ERRATA

**6110 Camino De La Costa
Environmental Impact Report
PRJ-1066101 / SCH No. 2023070270
August 5, 2024**

Subsequent to finalization of the Environmental Impact Report (EIR) No. 1066101, dated July 24, 2024, revisions to the environmental document have been made to adjust the driveway width from 18 to 12 feet. The following revisions to the environmental document have been made and are reflected in a ~~striketrough~~ and/or underline format.

Figure 3-1

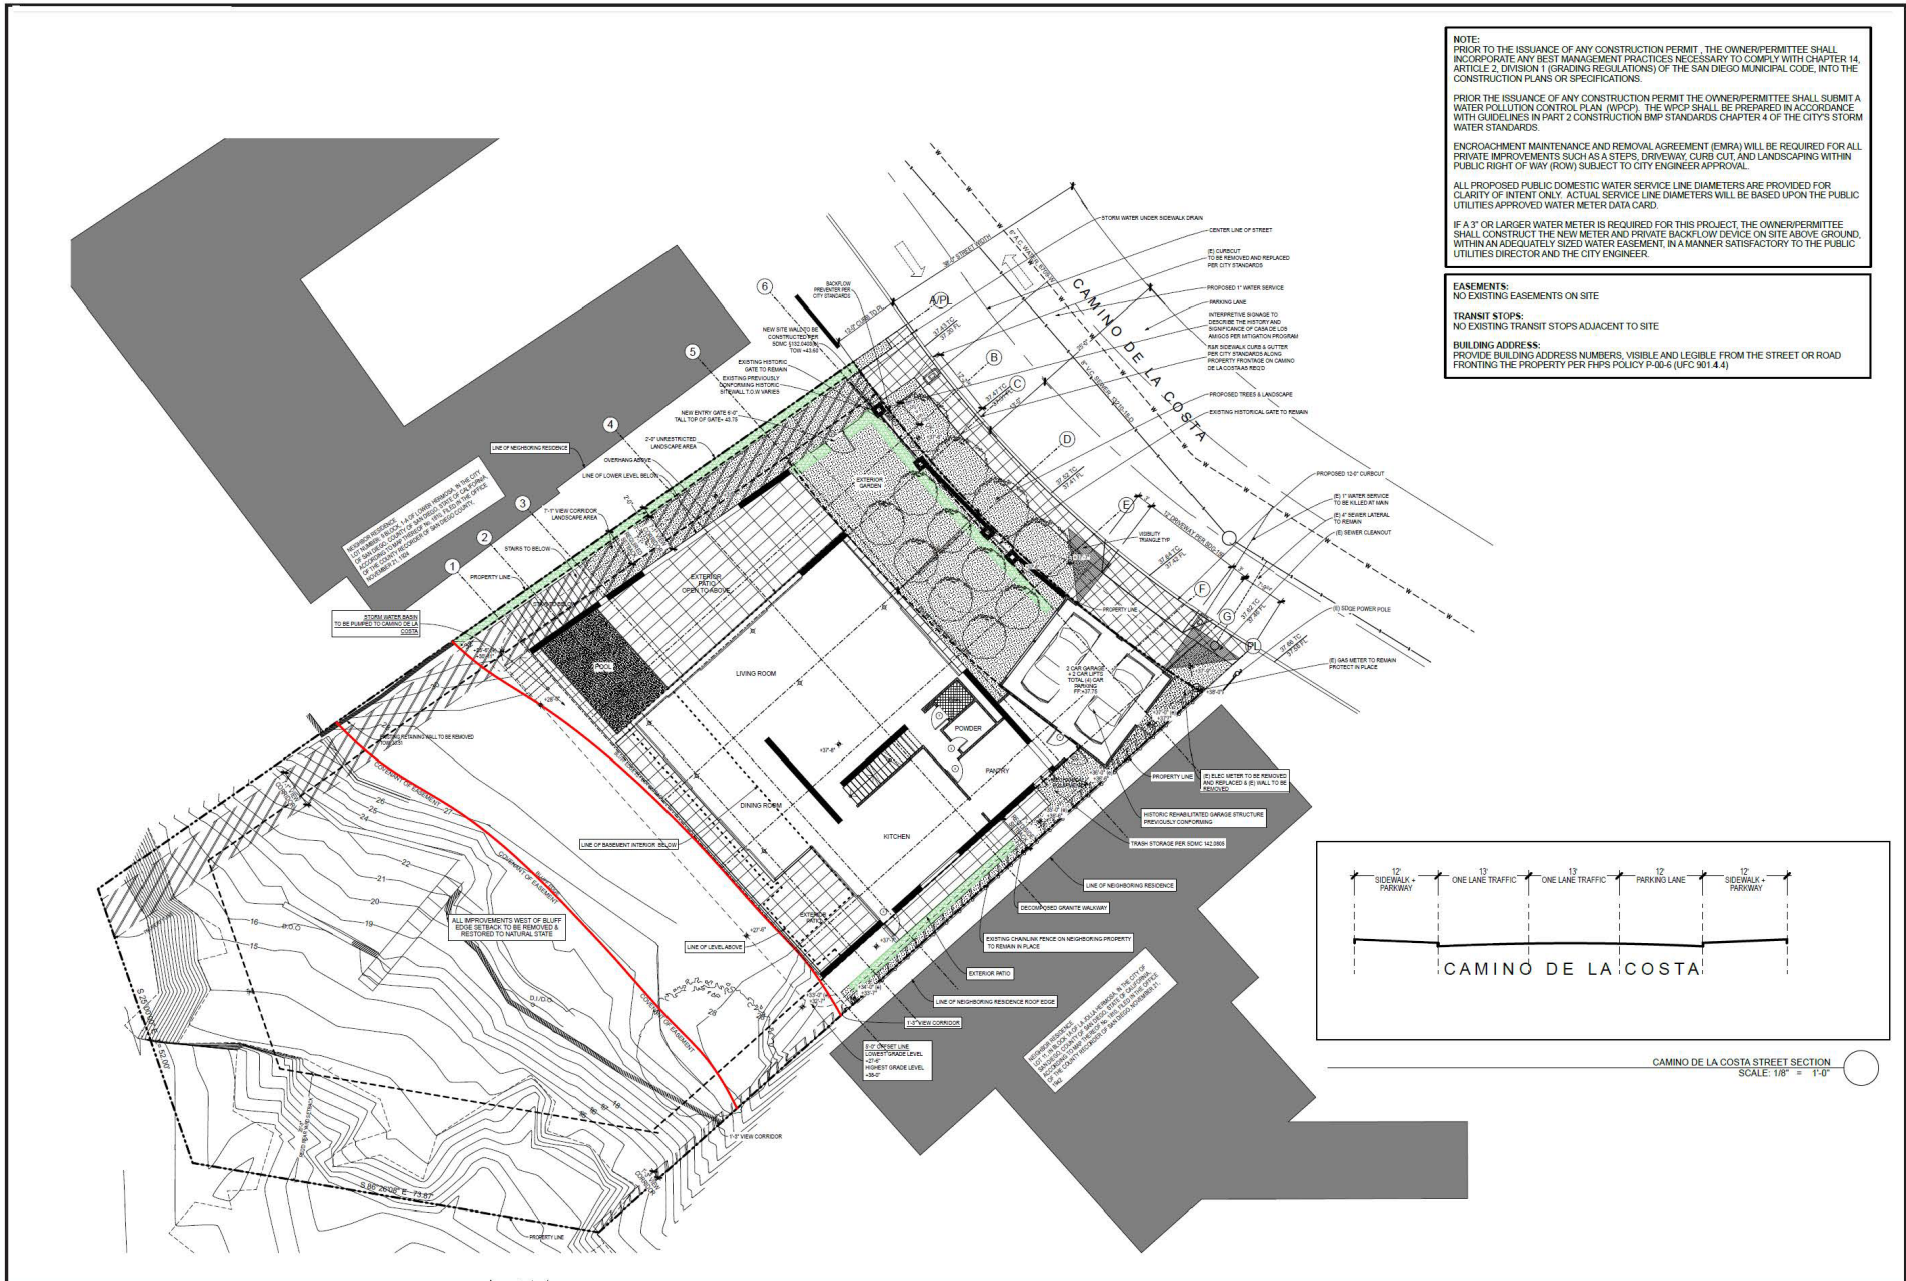
12. EIR Project Description, Figure 3-1, Site Plan has been revised as follows:
